NOTIFICATION - OCTOBER 03 2018

Elevator Piano Hinge and Stabilizer update

CH 750 Cruiser

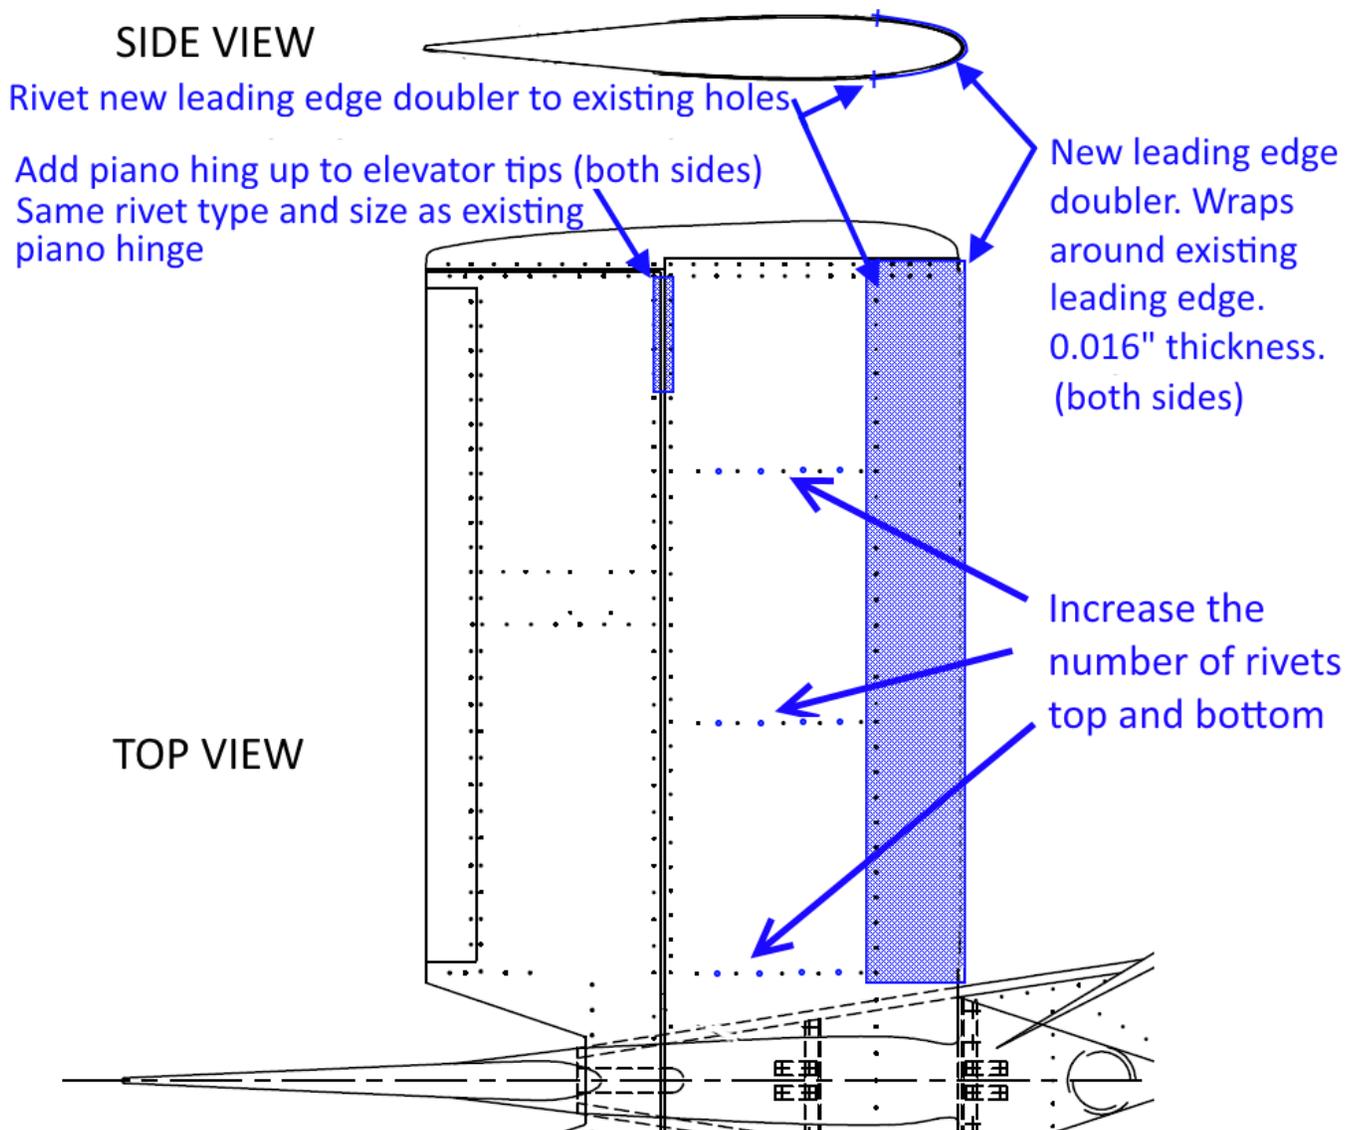
Rivets have been doubled up in the above photo on ribs centre ribs C75T1-2 and C75T1-3.

3. On Ribs C75T1-2, C75T1-3 the rivet spacing needs to be decreased from 60mm to about 30mm, which will increase the number of rivets between the front and rear spar. On those ribs there needs to be a total of 9 A4 rivets per side as shown in the above photo. Top and bottom.
